RE: Comments on the Revised Baseline Modeling Report

COMMENTS OF THE GENERAL ELECTRIC COMPANY ON

Phase 2 Report - Review Copy
Further Site Characterization and Analysis
Volume 2D - Revised Baseline Modeling Report
Hudson River PCBs Reassessment RI/FS
January 2000

November 2000

Figure 1. USEPA model predicted change in TIP fine sediment PCB inventory

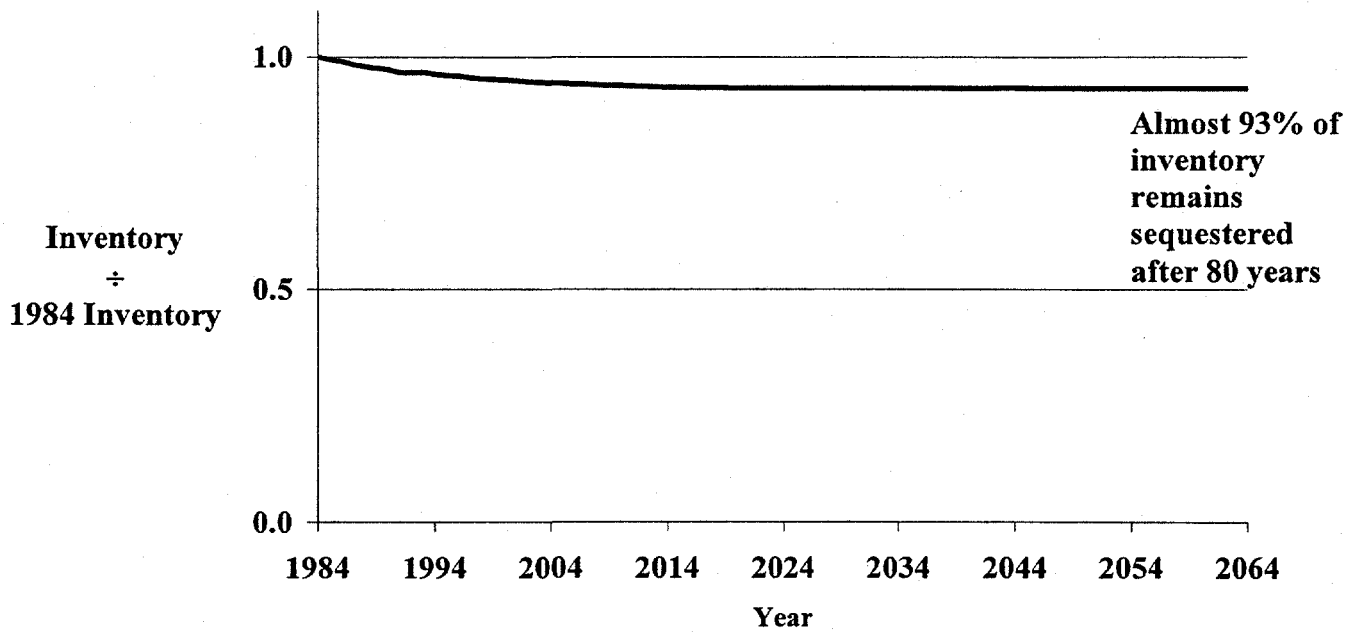
as evidenced by its ability to replicate the PCB concentration trends in the sediment and water column. It does so by burying PCBs in the sediment, principally in the cohesive sediments; the highest concentrations of PCBs typically occur below the bioturbated surface layer in the cohesive sediments. All of the cohesive sediment areas are subject to deposition and there is no indication from USEPA's modeling analyses that a significant fraction of the PCB inventory has been mobilized and redistributed from any of these areas. Unfortunately, USEPA did not present analyses of its model results that allow a quantitative comparison to the LRRCR results. We conducted such analyses using a copy of the USEPA model that USEPA provided to us. These analyses show that the model results and the LRRCR conclusions cannot be reconciled. For example, Figure 1 shows the USEPA model prediction for change in PCB inventory from 1984 to 2064, relative to the PCB mass established with 1984 data¹. Only 7% of the 18,000 lb. inventory leaves the sediment over this 80 year period; 93% of the PCB inventory is permanently sequestered as indicated by the plateau in the inventory change.

Figure 2. PCB mass balance in Thompson Island Pool 1984-1994 (numbers indicate kg of PCBs)

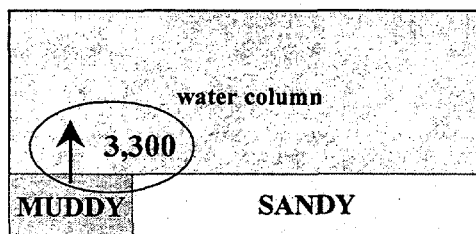
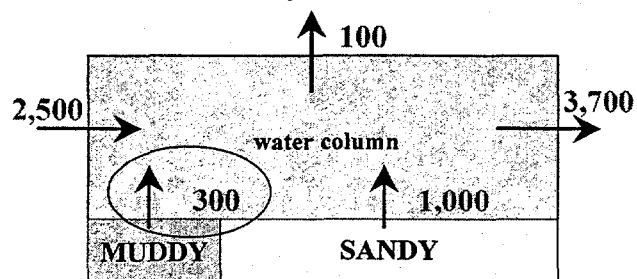
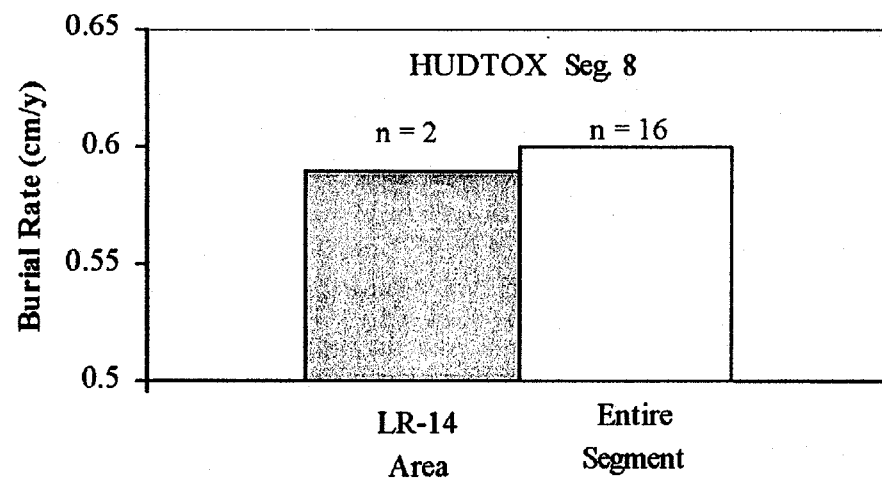
Figure 2 provides a further illustration of the discrepancy between the LRRCR and USEPA's modeling results in terms of PCB inventory. The conclusions in the LRRCR indicate that close to 40% of the PCBs in the cohesive sediments eroded to the water column from 1984 to 1994. The USEPA model, however, calculates a significantly different percentage with only 3% of the cohesive PCBs fluxing to the water column. The model results are consistent with data, while the LRRCR calculation cannot be reconciled with other inputs and outputs.

Figure 3. Comparison of GE model computed cohesive sediment burial rates in Low Resolution Coring Analysis Cluster Area 14 and in the larger area represented by Segment 8 of the EPA Hudtox Model

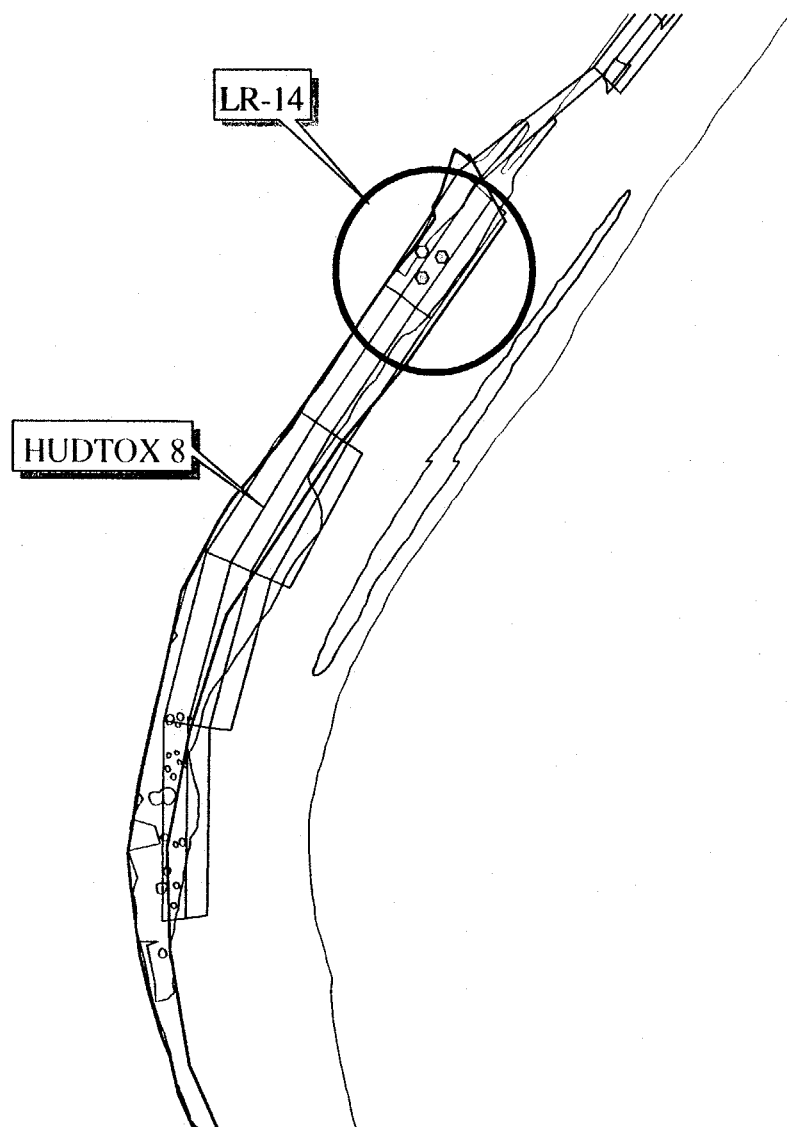
USEPA has made no attempt to determine whether such deviation exists. Such a determination can be made using the USEPA hydrodynamic and sediment erosion model, which has spatial resolution comparable to, or finer than, that of the geochemical analysis (see Figures 3-2 and 3-3 of the RBMR; USEPA, 2000). The General Electric hydrodynamic and sediment transport model, whose results were used by USEPA in calibrating its model, also has sufficient resolution to examine conditions on the scale of the geochemical analysis. As shown for each of the 1994 sampling clusters on which the geochemical analysis relies (Figures 3 to 7), the GE model indicates that the targeted locations are **not** erosional and tend to have greater deposition rates than the averages for the larger areas represented by the HUDTOX model.

Figure 8. USEPA model predicted fate of PCBs leaving TIP fine sediments between 1984 and 1994 (numbers indicate percentage distribution)

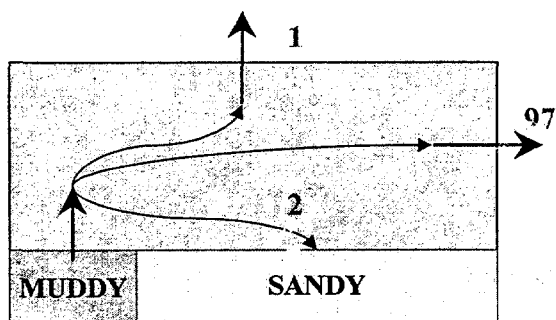
Another issue of concern is the fate of resuspended TIP sediments - do they travel over the dam to lower reaches or are they just redistributed within the TIP. On the basis of the LRCR the USEPA concluded that most of the PCBs fluxed from the fine sediments in the TIP were redeposited within the reach and did not travel downstream. However, the USEPA modeling results from 1984 to 1994 show the opposite story - only 2% of the fluxed PCBs remain within the TIP, while 97% travel over the dam to lower reaches and 1% are volatilized (Figure 9). It is important to note that the 2% redistributed within the TIP constitutes only 0.06% of the total PCB inventory in the fine sediments in 1984³. In direct contradiction to this finding the RBMR states on page 141: "...HUDTOX ... suggest[s] that there has also been a significant amount of redistribution of Tri+ mass within Thompson Island Pool from historical hot spots." We believe that our analysis of the HUDTOX results demonstrates that this statement is false. The RBMR must be revised to present a clear and accurate assessment of the model conclusions on this issue.

Figure 9. USEPA model estimate of the contribution of sources of PCB flux at Troy Dam in 1994.

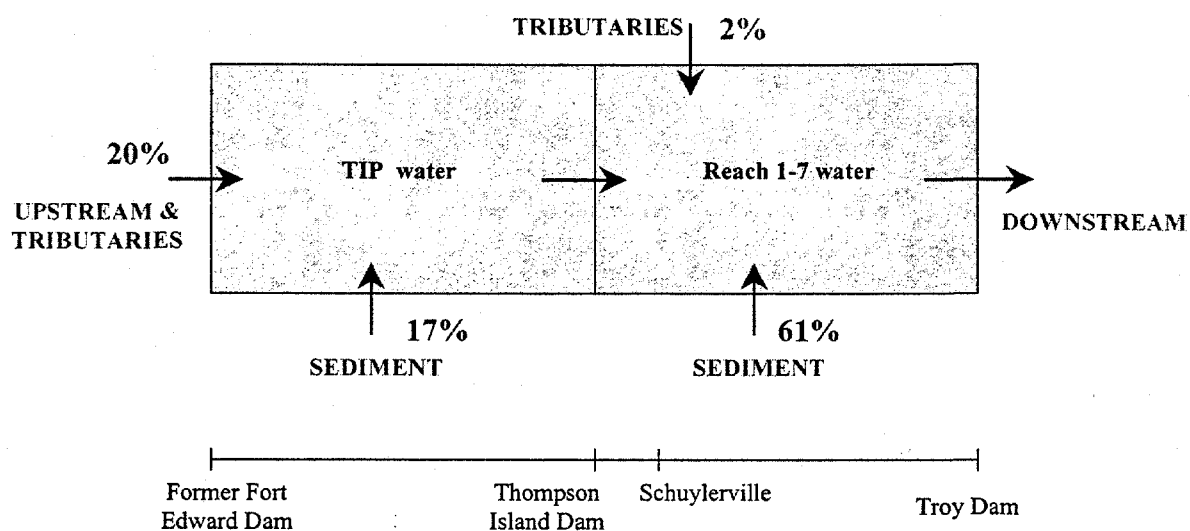
Of major concern to the USEPA and others is the origin of the PCBs seen in lower, freshwater Hudson. The DEIR concluded that the TIP is the major source of PCBs to the lower Hudson. However, analysis of USEPA's model shows that TIP sediments are actually a minor component of the load to the Lower Hudson River. Estimates from the model indicate that in total, 63% of the PCBs transported from the Upper Hudson to the Lower Hudson in 1994 originated from downstream of the Thompson Island Dam, while TIP sediments account for only 17% of the load at Troy Dam in that year (Figure 9). Of this 17%, less than one quarter comes from the cohesive sediments.

Figure 10. Illustration of the numerical simulation of erosion in HUDTOX.

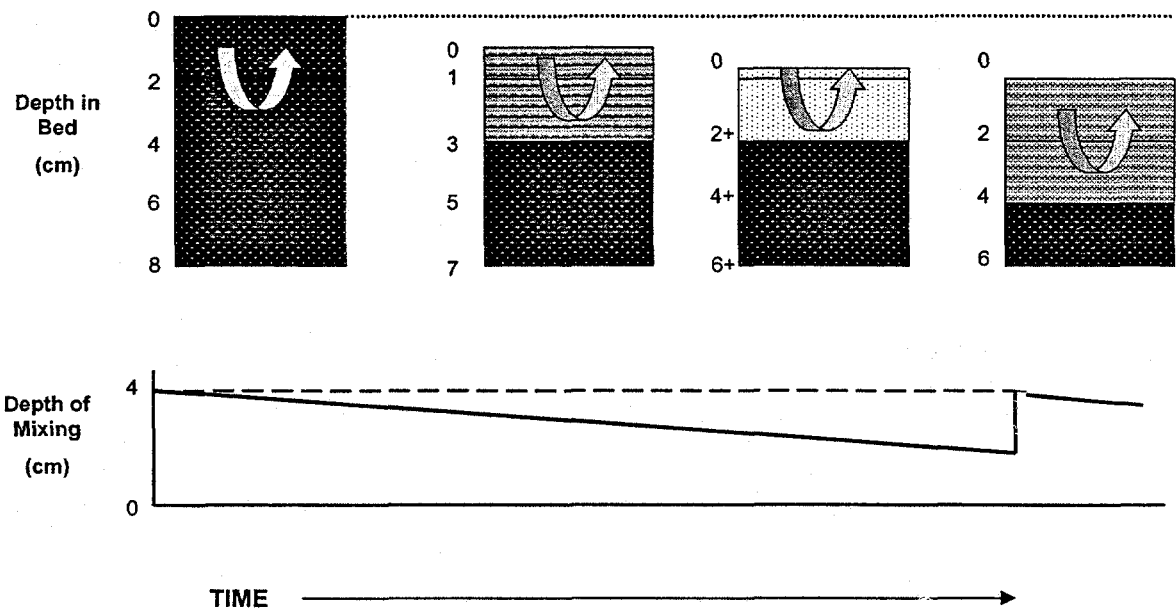
The model employs a 4 cm mixing depth. However, in areas of erosion or deposition, the model changes the depth of the surface mixed layer over time (i.e., the depth subject to significant bioturbation) as a consequence of the sediment segmentation scheme and the numerical procedure. Where net erosion is calculated, the depth of the topmost segment declines until it reaches a defined minimum value of a few millimeters. At that time, what remains of the top segment is incorporated in the segment below it, and the sediment segments are renumbered by the model (Figure 10). Because particle mixing is calculated for a specified number of segments (e.g., the top two segments in the non-cohesive sediments of the Stillwater reach), the model abruptly changes the depth of sediment subject to mixing. In the case of the non-cohesive area of the Stillwater reach that is calculated to undergo net erosion, the mixed layer declines from 4 cm to almost 2 cm, instantly increases to 4 cm and then begins to decline again. The sudden incorporation of a sediment segment that was previously below the mixing layer and not subject to PCB loss results in the calculation of a sharp increase in PCB concentration within the mixed layer (Figure 8-4c of the RBMR). The reason the increase occurs after 40-50 years is that the net erosion rate is approximately 0.04 cm/year, so it takes about 50 years until that next lower 2 cm thick segment is redefined as part of the "top two segments." This abrupt increase,

however, is not realistic, because in reality, the PCBs in the underlying layer will be made slowly available over the entire 40 year period, not instantly in the 40th year.

Figure 11. Illustration of the dependency of HUDTOX sediment PCB calculations in areas of net erosion on the choice of sediment layer thickness.

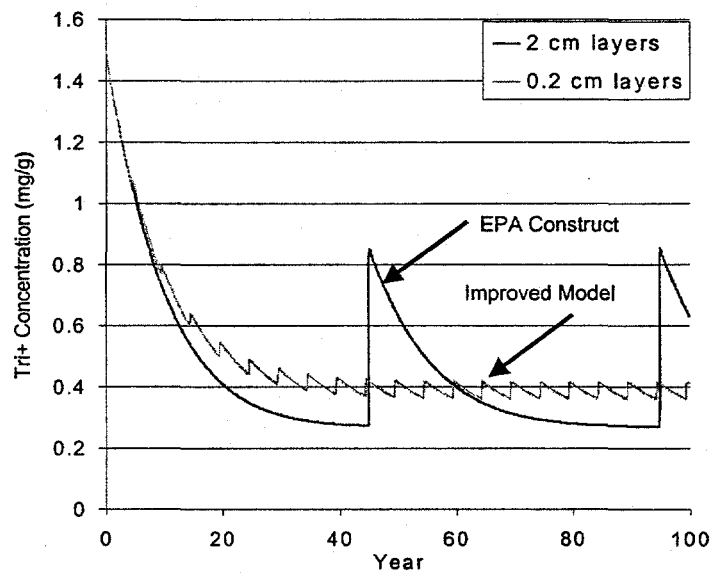
That the predicted increases are due to the model's numerical procedures rather than a real phenomenon is demonstrated by examining how the predicted increases change as the resolution of the numerical grid is changed. QEA ran its bed model using USEPA's parameters for particle mass transfer, net erosion, and molecular mass transfer as well as a mixing depth of 4 cm as was used in the Stillwater Reach. The model was run with a segment thickness of 2 cm as well as 0.2 cm to demonstrate that the apparent increase is easily reproducible and a function of layer thickness. We were able to reproduce the sudden increase when using 2 cm layers (Figure 11). As the sediment model segmentation was refined, the sharp increases due to this numerical artifact began to disappear. As shown in Figure 11, use of segments 0.2 cm thick results in near complete elimination of the increases.

Figure 12. Comparison of USGS and GE solids load sampling methods.

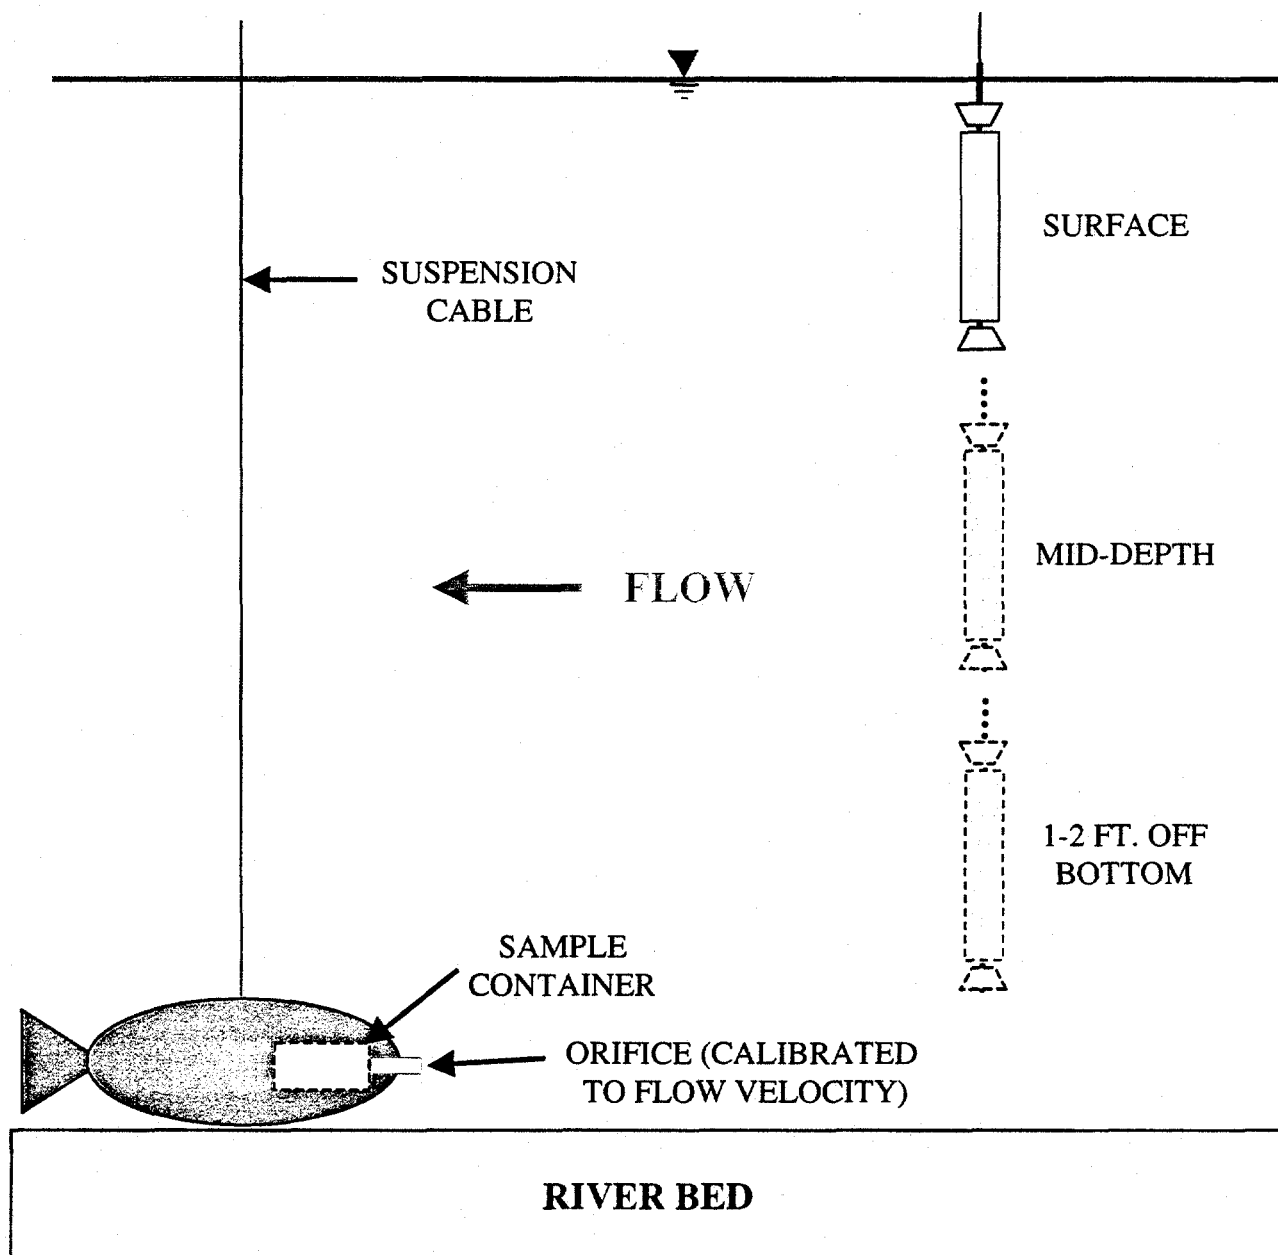
First, the USGS methodology is specifically designed to measure sediment loads, whereas GE's methodology is not. GE samples are taken at three locations in the water column: 0.2, 0.5 and 0.8 times the depth (e.g., in 2 m of water, the bottom GE sample would be 40 cm

above the sediment bed). The USGS method, in contrast, utilizes a sampler that samples continuously throughout the water column, from the surface to within 6 cm of the sediment bed. Thus, the GE method does not produce a vertically-averaged TSS concentration that adequately samples near-bed sediments, where a major fraction of the suspended sand load is located. In addition, the USGS sampler is a flow-through device that is specifically designed for sampling suspended sediment. A Kemmerer sampler is used by GE to collect TSS samples. The design of this device is such that suspended sands, with relatively high settling speeds, may not be adequately sampled. Second, the USGS methodology has remained constant throughout the relevant period (i.e., 1977 to the present), whereas GE's different methodology was introduced in 1990. It is far preferable to use a consistent data set than to rely on data collected from two different methodologies. Thus, it is appropriate to rely on the USGS data set to establish solids loading over time at Fort Edward.

Figure 13. Estimated solids loading at Ft . Edward for post-1990 (1991-1998) period using various rating curves. Error bars represent the 95 % confidence interval.

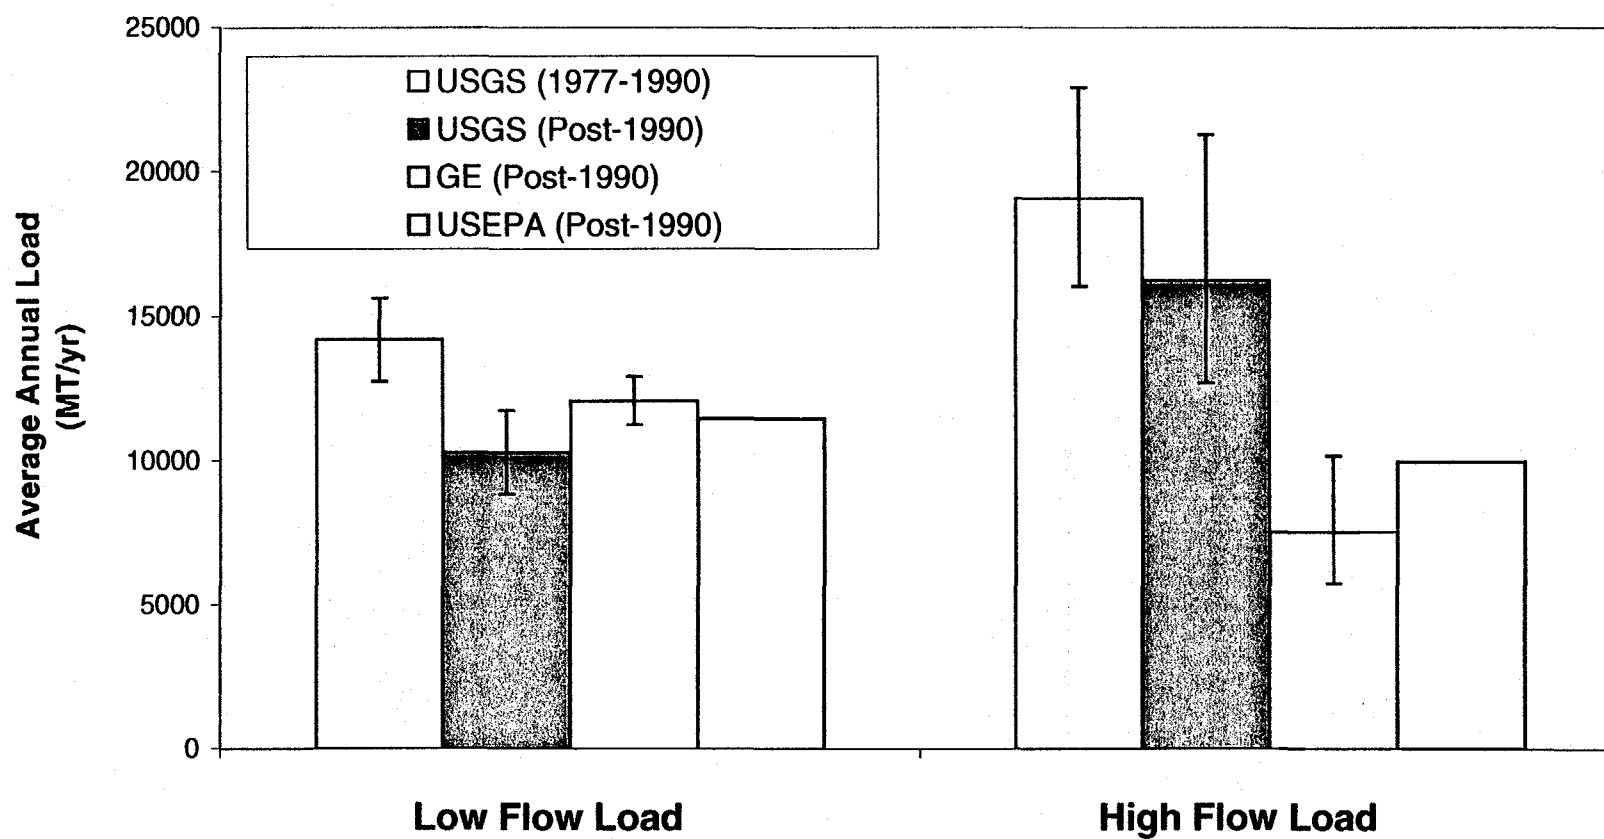
rating curves, particularly in the high-flow regime, are evident in Figure 14. These rating curves were used to calculate Fort Edward solids loading for an eight-year period, from January 1, 1991 to December 31, 1998 (Figure 13). The rating curve developed from the GE data produced a total solids load for this period that was 24% lower than the USGS rating curve overall, with a much larger difference during high-flow periods (54% lower) than during low-flow periods (17% higher). The apparent low-bias of the GE TSS concentration data during high-flow conditions probably results from the configuration of the sampling device and the sampling procedure, as described previously (Figure 12). Thus, the GE TSS concentration data should not be used for calculating total suspended solids loading at Fort Edward.
